Integrated Device Technology, Inc.

Manufacturing Bulletin

Subject: EIA-481-D Taping of Surface Mount Components for Automated Handling.

Tape & Reel Loading Orientation per EIA-481C ---> Pin 1 in Quadrant 1

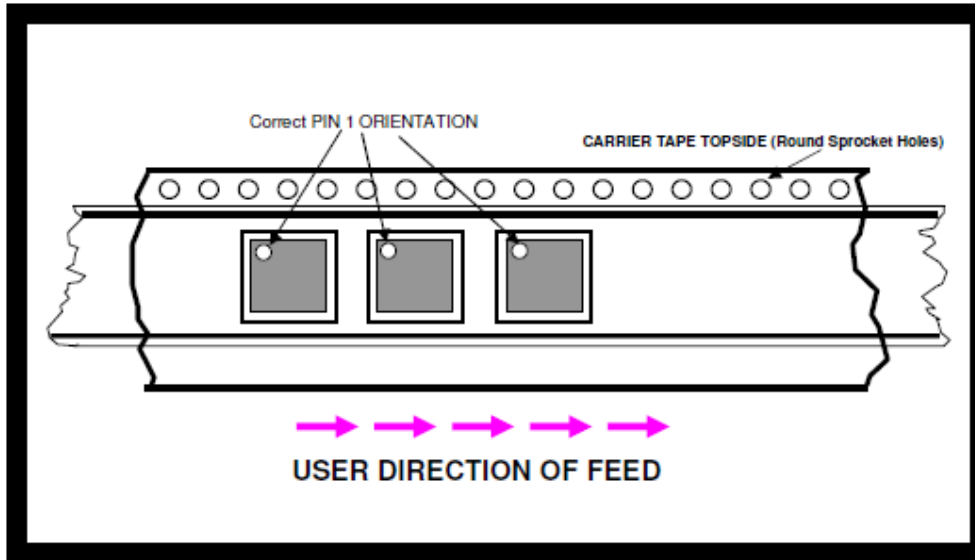
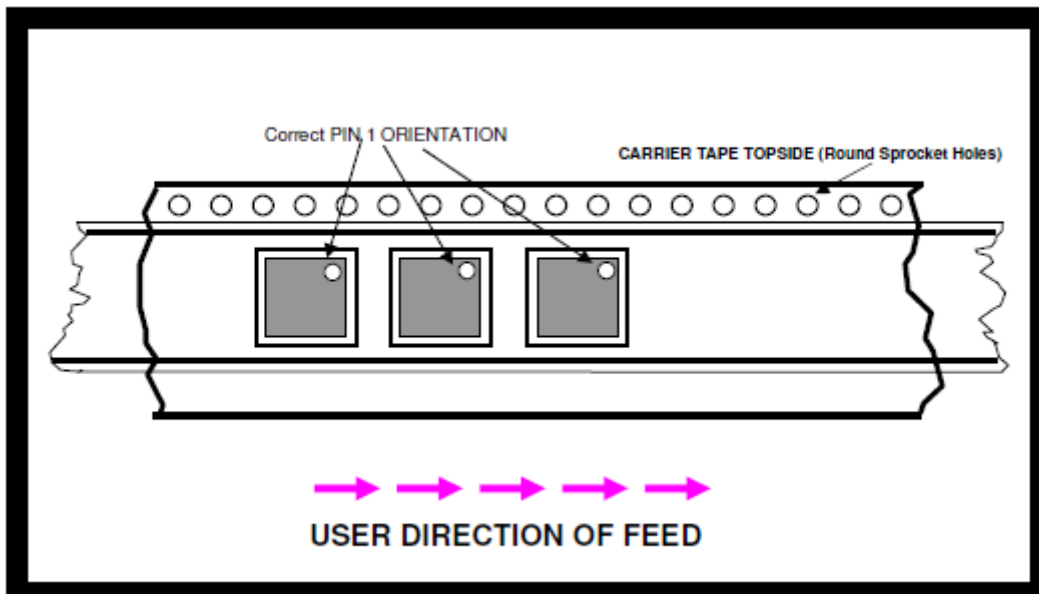
This notification is to address IDT compliancy with EIA-481-D. We have completed the study between IDT's current component orientation of Pin 1 in Tape and Reel packing and the orientation specification EIA-481-D. IDT complies with EIA-481-D except for some of the square QFP and QFN packages. Table 1 lists the packages and current orientation of Pin 1, which is in Quadrant 1, while the EIA-481-D requires orientation of Pin 1 in Quadrant 2.

Refer to Figure 1 and Figure 2 in Attachment 1 for an illustration of the Tape and Reel loading for Pin 1 orientation.

Changing Pin 1 orientation for these packages in order to comply with Rev D would be disruptive to the majority of our customers who have received shipments with this orientation in the past 4 years.

IDT will offer a special orderable part# (with "W" suffix added to the existing part#) to provide for shipments in Tape & Reel with pin 1 orientated in Quadrant 2 for the packages listed in Table 1. This special part # will be available upon request.
